Groundwater Application Review Summary Form

Application # G- 19213

PUBLIC INTEREST REVIEW FOR GROUNDWATER APPLICATIONS

TO: Water Rights Section Date 10/29/2021
 FROM: Groundwater Section Phillip I. Marcy
 Reviewer's Name
 SUBJECT: Application G- 19213 Supersedes review of _____
 Date of Review(s)

Well Location Map

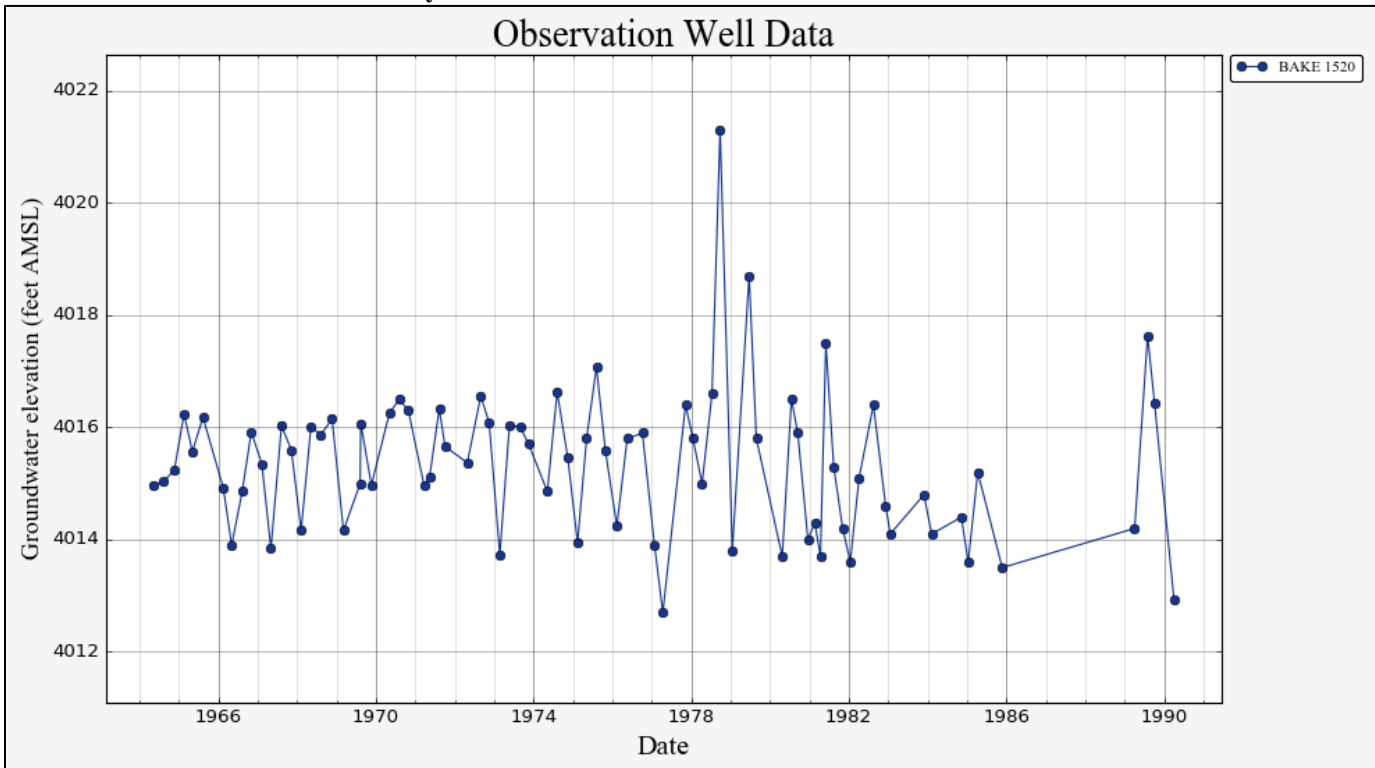
Comments: Due to its location within less than one mile from Job Creek and very low dry season flows, POA Well 1 has triggered Potential to Substantially Interfere (PSI) with local surface water. POA Well 2 is not within one mile of local surface water sources.

POA well 2 is outside of one mile from Job Creek, and therefore was not evaluated for impacts under Division 9, but POA well 1 is within one mile of the creek, and has triggered PSI under Division 9, due to the pumping rate being greater than 1% of the 80% exceedance rate for Job Creek (0.08 CFS). In order to overcome this finding, POA well 1 must be moved to a location outside of 1 mile from Job Creek, or the rate must be lowered to 0.0008 CFS.
